Subject: 2005 Q45 Rear Seat LATCH System Recall Campaign Update #1

VOLUNTARY RECALL CAMPAIGN Q45 REAR SEAT CHILD RESTRAINT ANCHOR BRACKETS

CAMPAIGN I.D. # / NHTSA #: R0503 / 05V-374

APPLIED VEHICLE: 2005 Q45 (F50) – with power rear seats ONLY

Figure 1

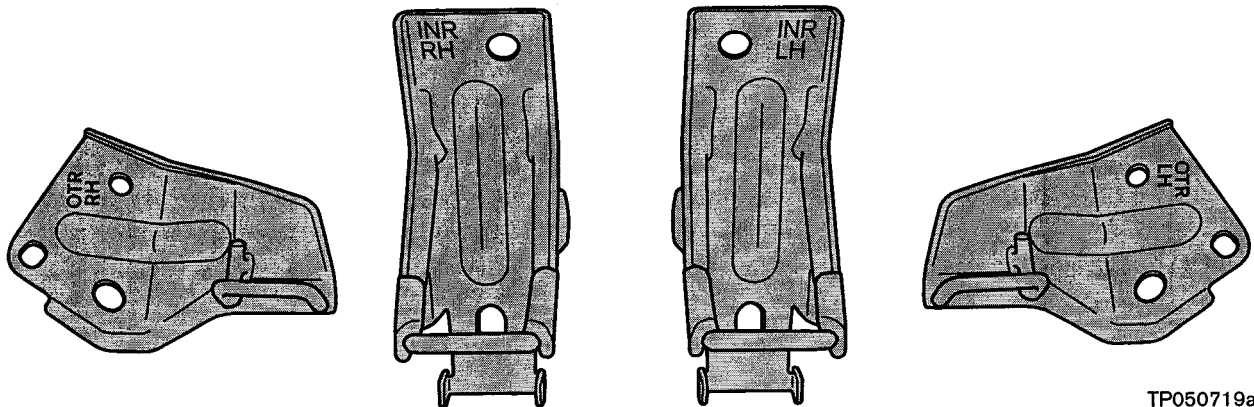
Install **four** new Rear Seat Child Restraint Anchor Brackets (see Figure 1) using the Service Procedure starting on the next page.

NEW REAR SEAT CHILD RESTRAINT ANCHOR BRACKETS

OLD REAR SEAT CHILD RESTRAINT ANCHOR BRACKETS

Figure 9

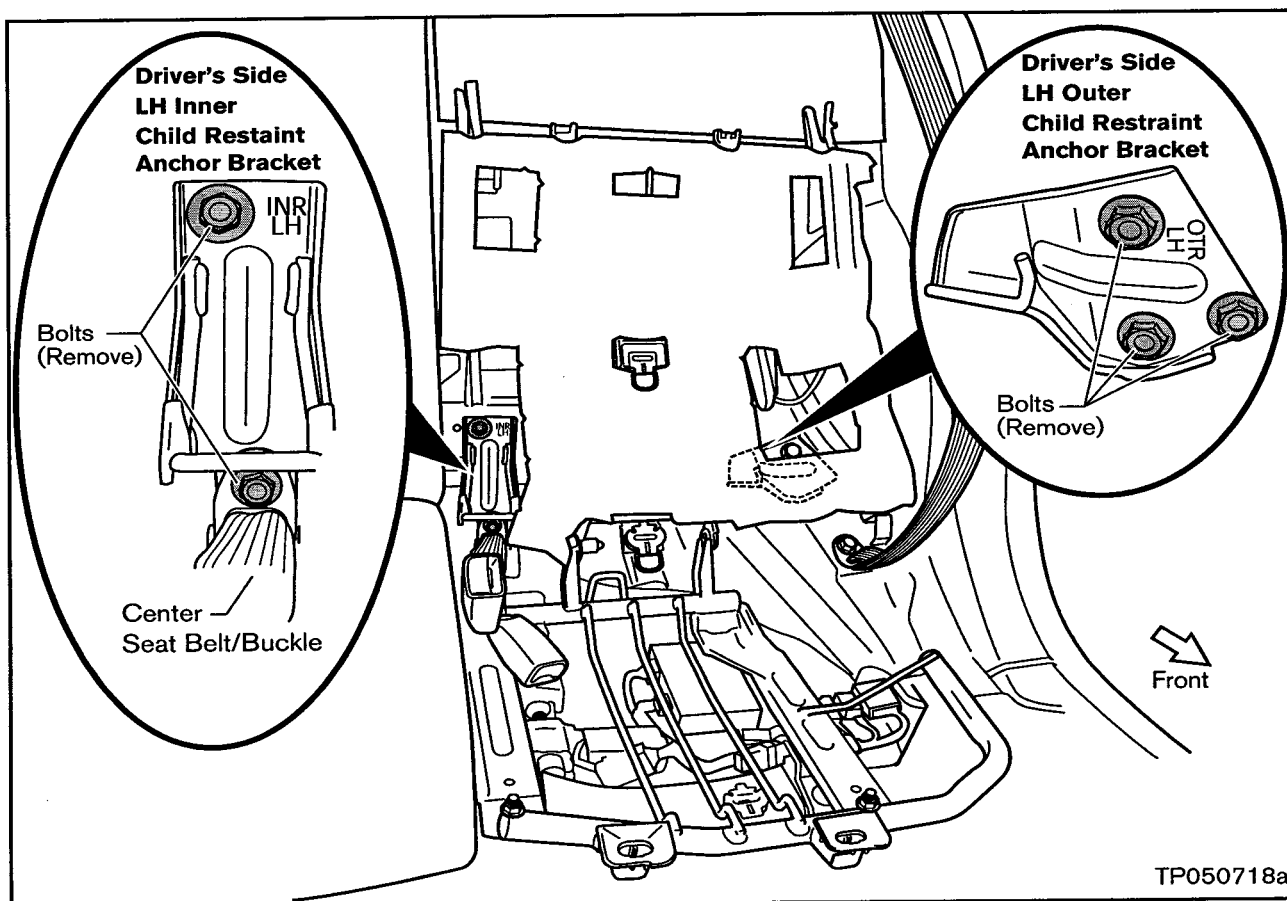
- 3. Remove three Bolts and remove the driver's side LH Outer Child Restraint Anchor Bracket (see Figure 9).
- 4. Remove two Bolts and remove the driver's side LH Inner Child Restraint Anchor Bracket (see Figure 9).

1. Install the new driver's side LH Outer Child Restraint Anchor Bracket with three Bolts (reuse original bolts).
 - Tighten the three Bolts to **49 N-m (5 kg-m, 36 ft-lb)**.
2. Install the new driver's side LH Inner Child Restraint Anchor Bracket with two Bolts (reuse original bolts).
 - Tighten the two Bolts to **49 N-m (5 kg-m, 36 ft-lb)**.
 - Make sure the center Seat Belt/Buckle is re-attached with the Child Restraint Anchor Bracket Lower Mounting Bolt (see Figure 10a). Also, make sure the Seat Belt is routed through the Seat Belt Guide Bracket (see Figure 10b).
